Groundwater Review Summary Form

Application # G- 18328

GW Reviewer Phil Marcy Date Review Completed: 1/24/2017

TO: Water Rights Section Date 01/24/2017
 FROM: Groundwater Section Phillip I. Marcy
Reviewer's Name
 SUBJECT: Application G- 18328 Supersedes review of _____
Date of Review(s)

Figure 1: Proposed POA location (yellow dot) and its proximity to nearby wells (green dots) and surface waters. The yellow circle indicates one-quarter mile from the POA in all directions.

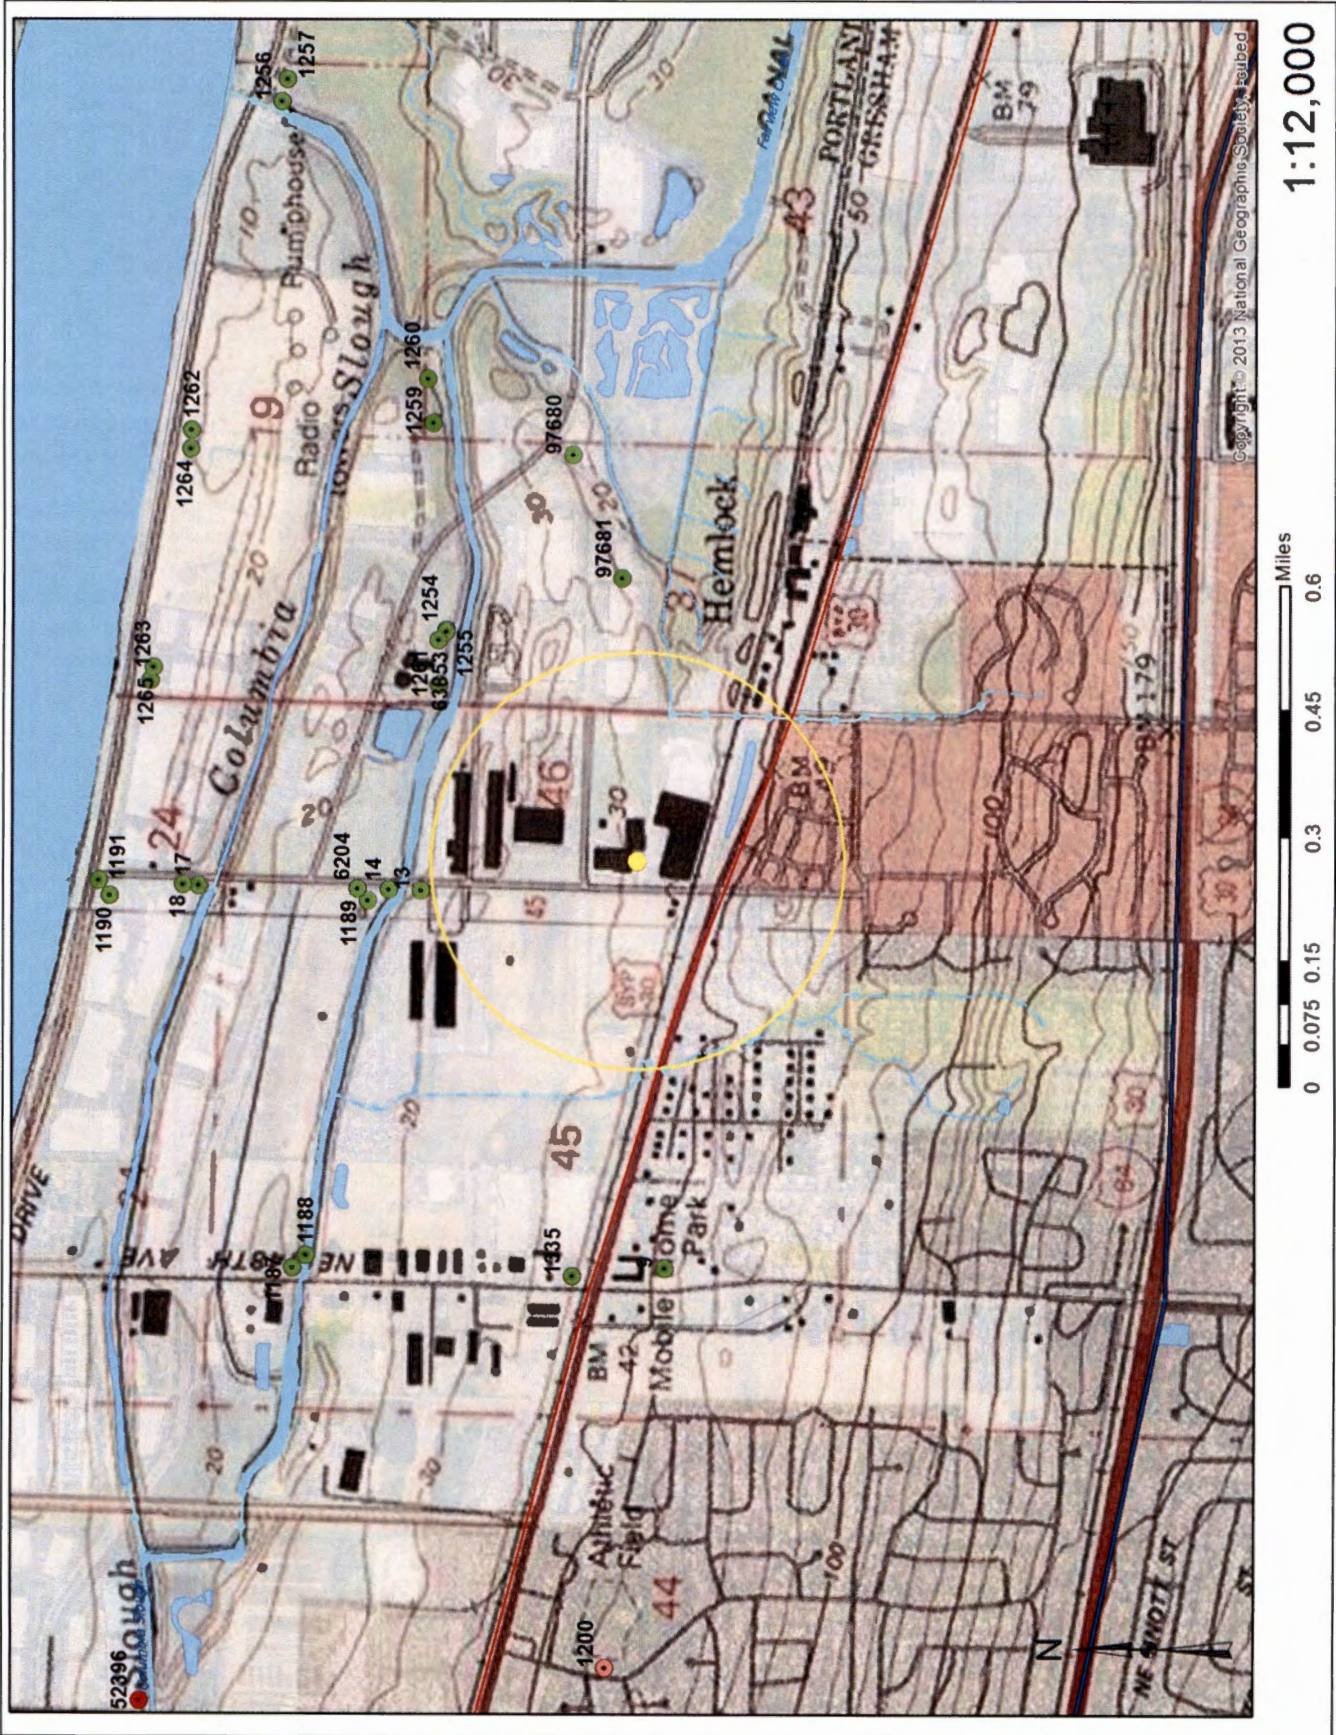
A4. **Comments:** The proposed POA well location is near the City of Portland's municipal well field next to the Columbia River, and proposes to produce from unconfined alluvium, likely Troutdale Formation gravels. The applicant states that the well is be used as a backup supply, in case the municipal supply is contaminated. The maximum rate requested is 1.56 cfs, however the total acre-feet per year on the application is 461 AF, averaging 0.636 cfs. The impacts of pumping at the proposed POA location shall be evaluated at the higher rate, however, in case the rate of 1.56 cfs is sustained for extended periods of time.

Figure 2: Hydrograph for nearby well MULT 52396, located ~6200' ENE of the proposed POA location.

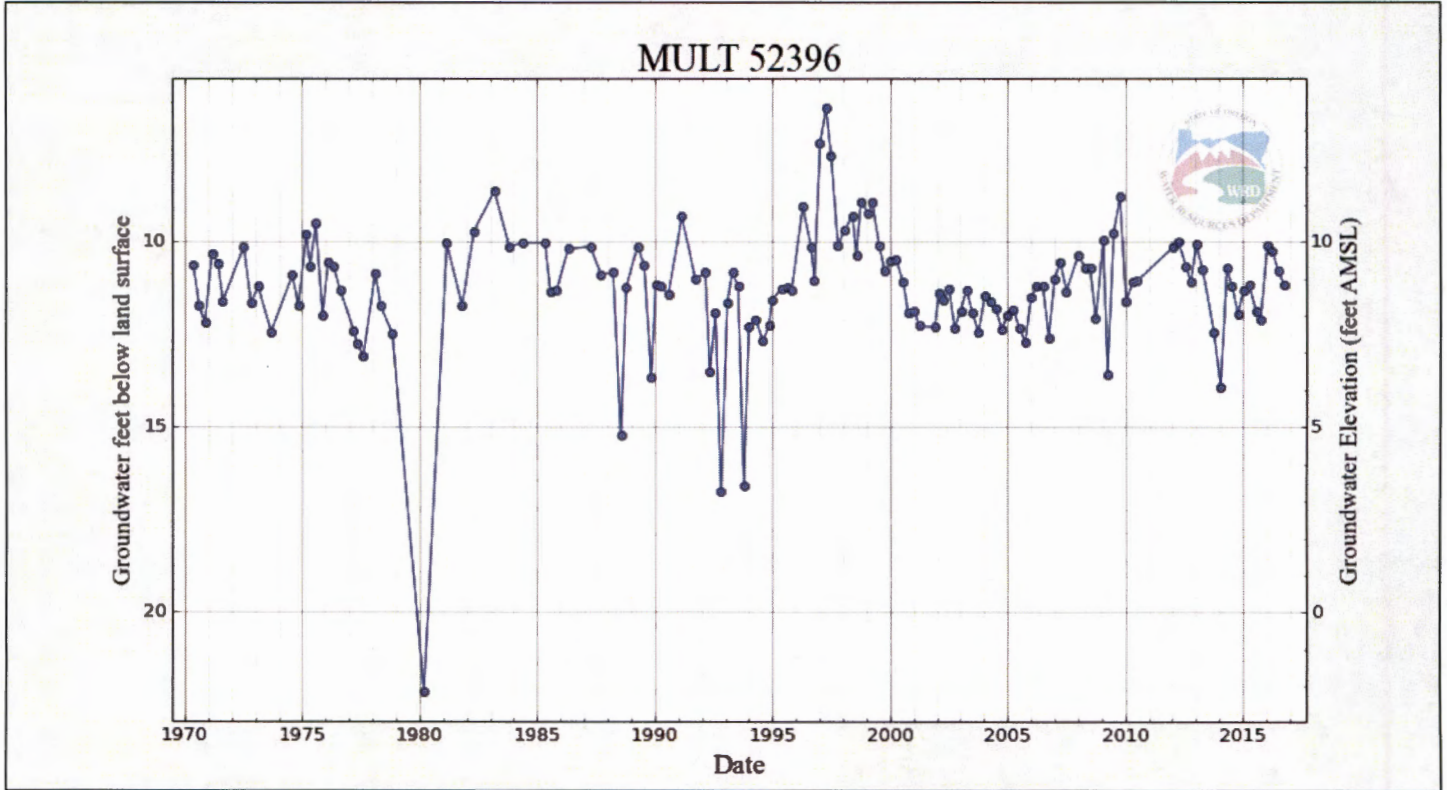
B3. **Groundwater availability remarks:** The proposed point of appropriation is likely to have a high degree of hydraulic connection to the Columbia River and Columbia Slough. Nearby observation well MULT 52396, located 6200 feet ENE of the proposed POA location, shows stable water levels for the entire record since 1970 (see attached hydrograph).

Figure 3: Expected stream depletion using the model of Hunt (1999) and the most likely aquifer parameters (scenario 2; red lines).

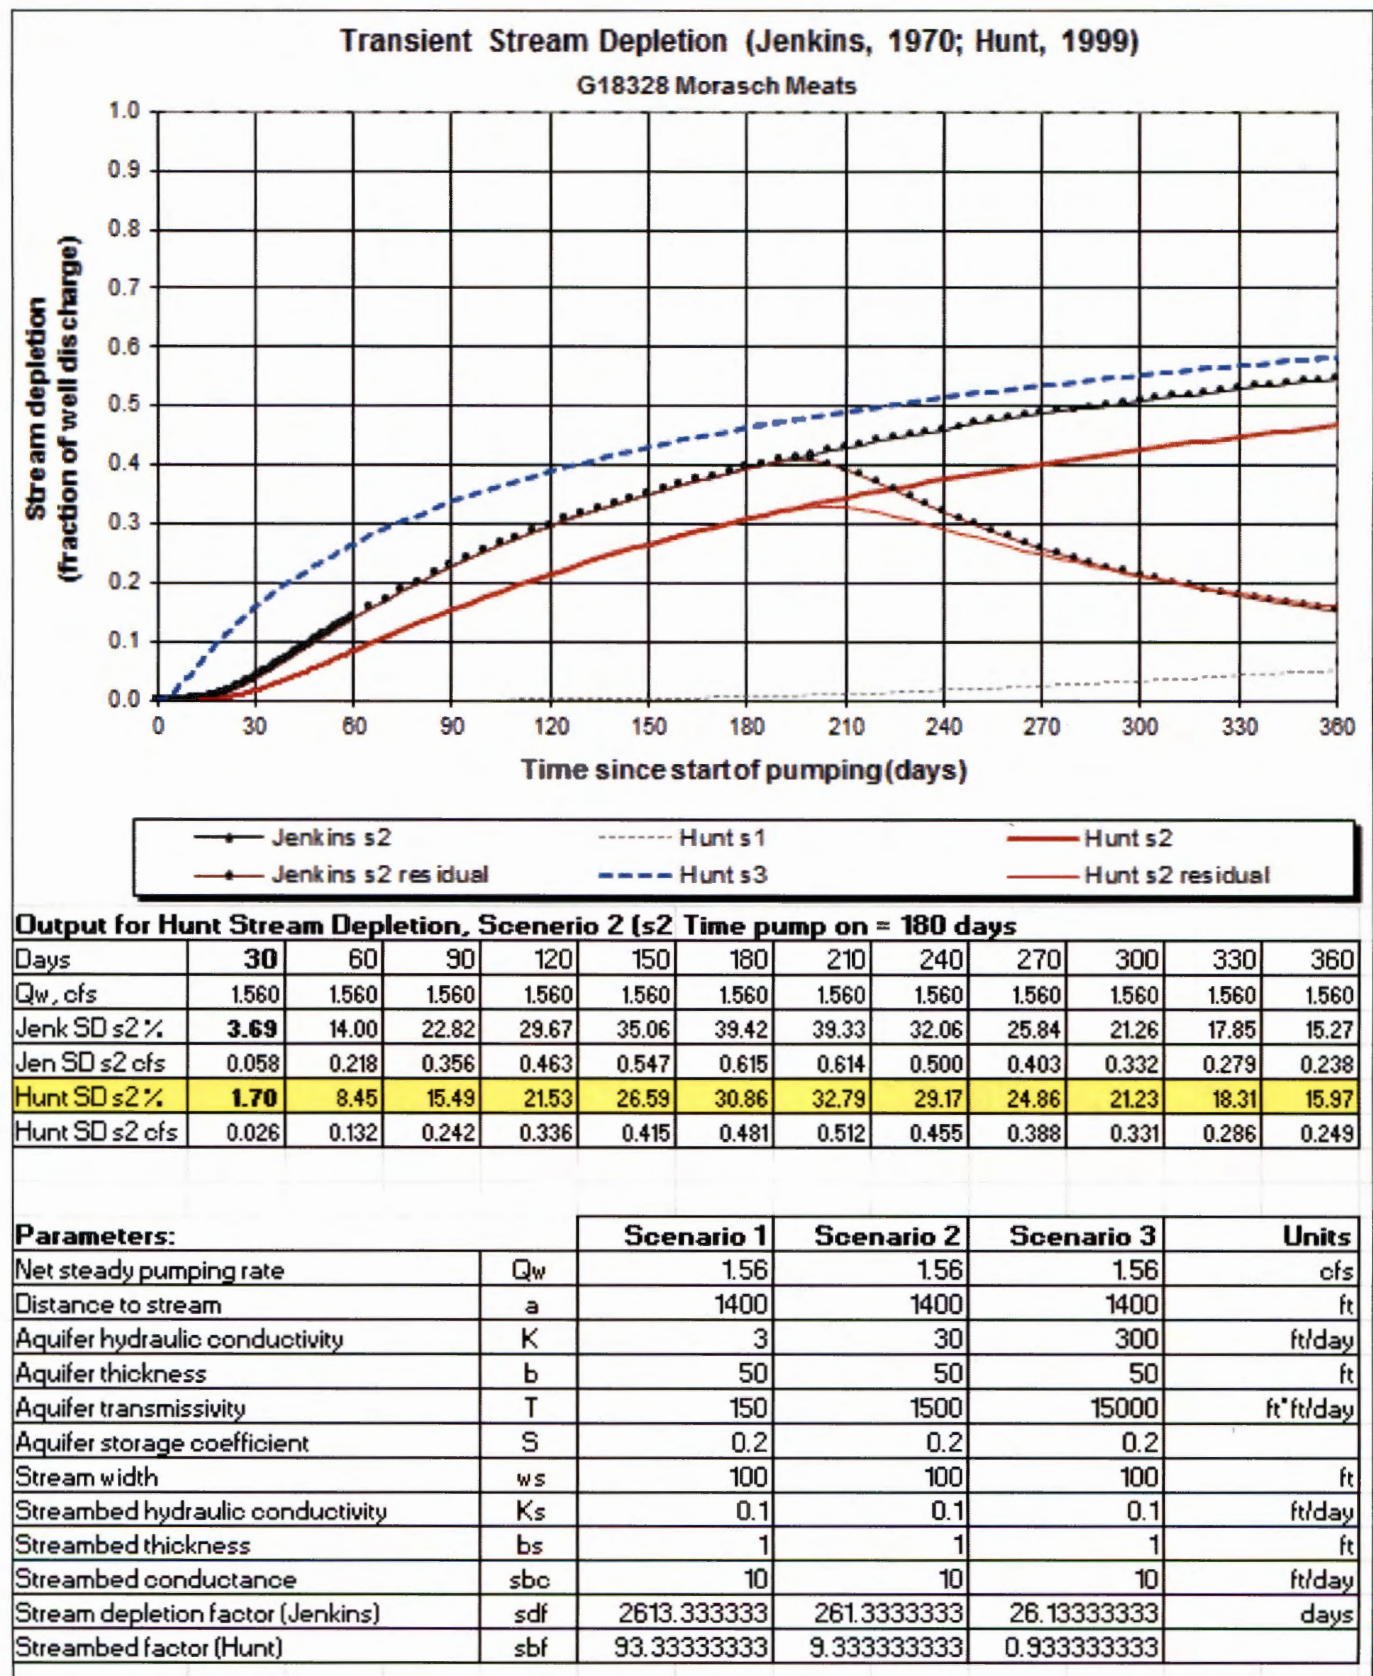
C6. **SW / GW Remarks and Conditions:** An evaluation of potential stream depletion was composed using the model of Hunt (1999), using the most likely aquifer parameters for the gravel-dominated portion of the Troutdale Formation (see attached). The results of this model run show that the percentage of pumped water coming from the Columbia Slough at 30 days is much less than 25%. The applicant stated that this well is to be used in emergency situations, if the municipal supply is interrupted or contaminated. I do not expect significant impacts to nearby surface waters from pumping at the proposed location and aquifer.
